SUBJECT: U.S. NUCLEAR REGULATORY COMMISSION/U.S. DEPARTMENT OF
ENERGY CONFERENCE CALL REGARDING QUALITY ASSURANCE AND
PERFORMANCE ASSESSMENT ISSUES

Summary of Audit Findings on Hand Calculations in the TSPA-SR Model Report

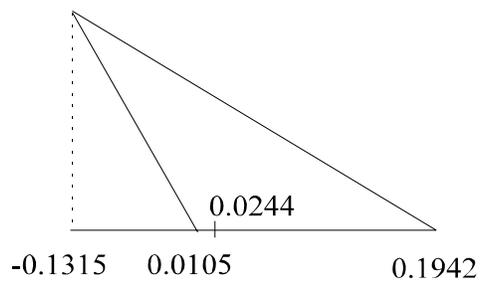
If the mean is 0.0244, the peak of the distribution is at -0.1315. As shown in figure 1, the peak lies outside the range represented by the minimum and the maximum values. When parameters are sampled from such a distribution, values outside the range will have two probabilities of occurrence. One value cannot have two different probabilities of occurrence from any distribution function.
